**Subject: Official Plan and Zoning By-law Amendment –Part of 1900 and 2000 City
Park Drive**

File Number: ACS2025-PDB-PS-0007

Report to Planning and Housing Committee on 3 December 2025

Figure 1: Preliminary Proposed Concept Plan presented to Urban Design Review Panel on February 7, 2025.

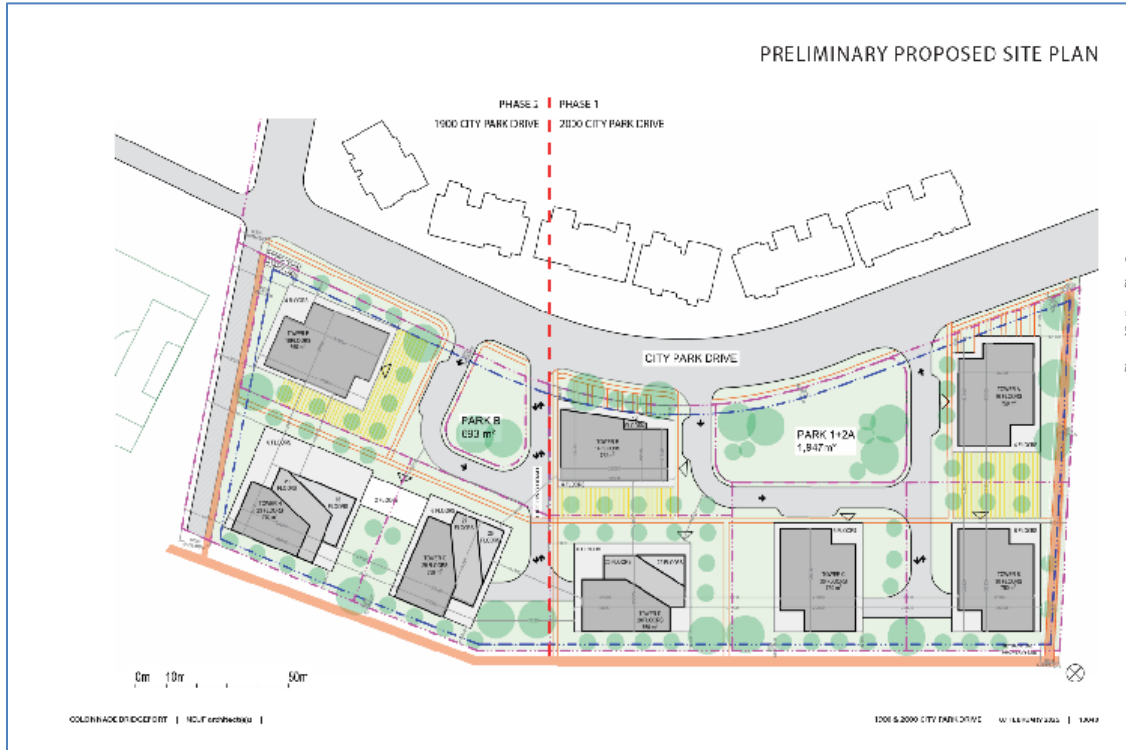
- The Panel appreciates the high-quality renders, especially at the ground level, in the presentation and the level of thought that went into the master plan.

- Reducing sameness is a common theme, and more diversity in building heights, forms, and character should be considered.
- Some Panel members encouraged that the master plan be guided by landscape design, emphasizing discovery and joy while incorporating carbon sequestration strategies.

- The Panel recommends that the park should not feel like an island surrounded by roadways but should instead be better connected and integrated into the site plan.

- The Panel recommends reducing the road network in the plan. There are opportunities to reduce the amount of asphalt, particularly by exploring an East-West High Street.
